## Proposal for Supplement 2 to the 01 series of amendments to UN Regulation No. 141 (Tyre pressure monitoring systems)

### Submitted by the Working Party on Noise and Tyres\*

The text reproduced below was adopted by the Working Party on Noise and Tyres (GRBP) at its seventy-fifth session (ECE/TRANS/WP.29/GRBP/73, para. 26). It is based on ECE/TRANS/WP.29/GRBP/2022/2 as amended by informal documents GRBP-75-10 and GRBP-75-33. It is submitted to the World Forum for Harmonization of Vehicle Regulations (WP.29) and to the Administrative Committee (AC.1) for consideration at their June 2022 sessions.

**“Figure 1**  
Refilling check

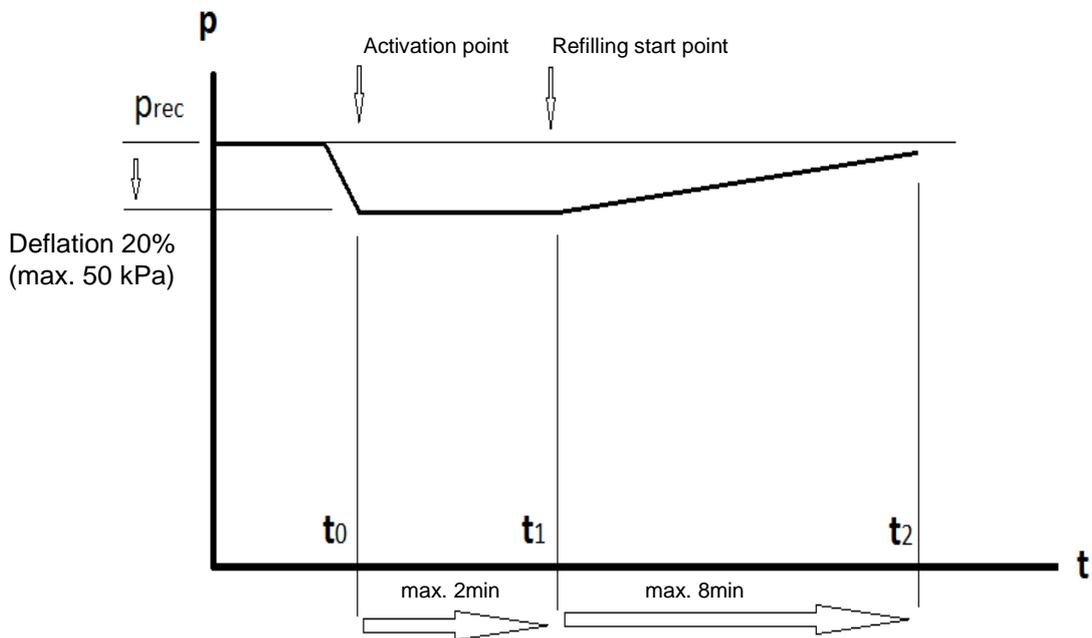
“2.5.1. Check refilling according to Figure 1

Check that within 2 minutes, when the system is operational, the TPRS/ CTIS starts refilling and at least after 2 minutes the low tyre pressure tell-tale, as described in paragraph 5.5. of the Regulation, is “On”.

Refill process shall be completed within 8 min after the refill process has started and the low tyre pressure tell-tale, as described in paragraph 5.5. of the Regulation, is “Off” as soon as the refilling process is completed.

After the refilling process has been completed, check that the tyre pressure is in a range of +/- 5% of manufacturers recommended cold inflation pressure  $P_{rec}$ .”

*Figure 1, amend to read:*

**“Figure 2**  
Checking system malfunction warning functionality.

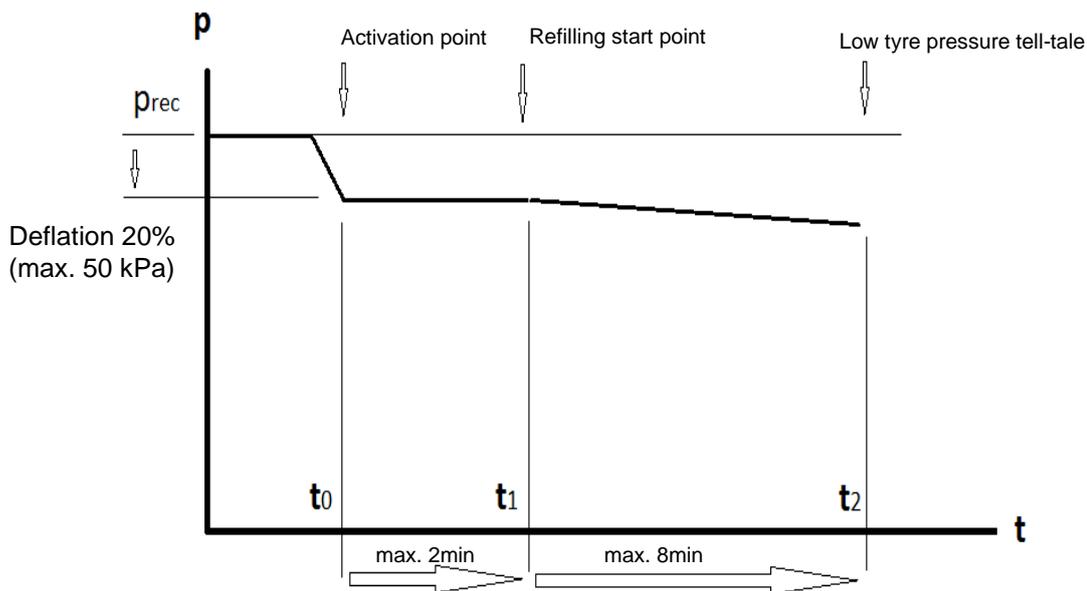
“2.5.2. Check refilling according to Figure 2

Check that within 2 minutes when the system is operational the TPRS/ CTIS starts refilling and at least after 2 minutes the low tyre pressure tell-tale, as described in paragraph 5.5. of the regulation, is “On”.

Refill process shall not be completed within 8 min after the refill process has started and the low tyre pressure tell-tale, as described in paragraph 5.5. of the regulation, is “ON” after at least 2 minutes of refilling time.

The deflation rate during the test must be higher than the refilling rate.”

Figure 2, amend to read:

“Figure 1  
Arrangement of device under test and vehicle simulator where TPMS/ TPRS/ CTIS functionality is provided by ECU connected via ISO 11898-1:2015 and 11898-2:2016 interface

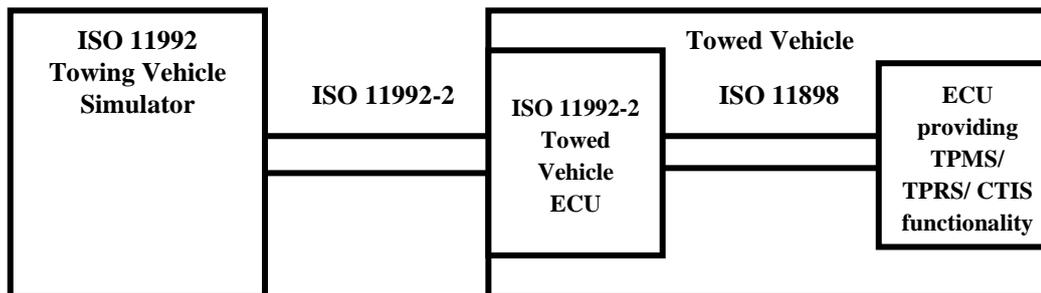
Figure 1, amend to read:

“Figure 2  
Arrangement of device under test and vehicle simulator where TPMS/ TPRS/ CTIS functionality is provided by ECU connected to towing vehicle

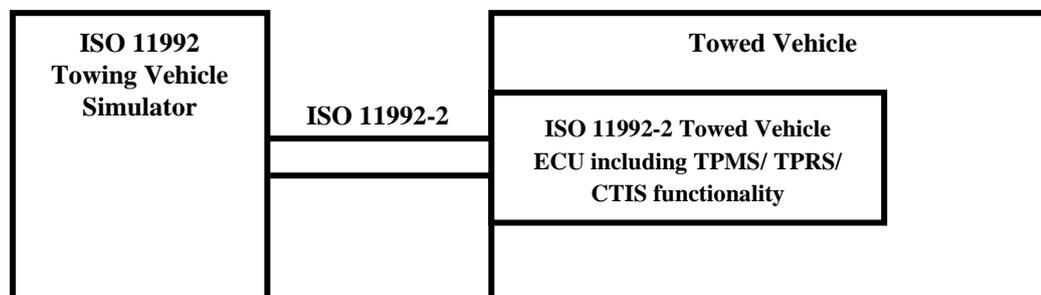
Figure 2, amend to read:
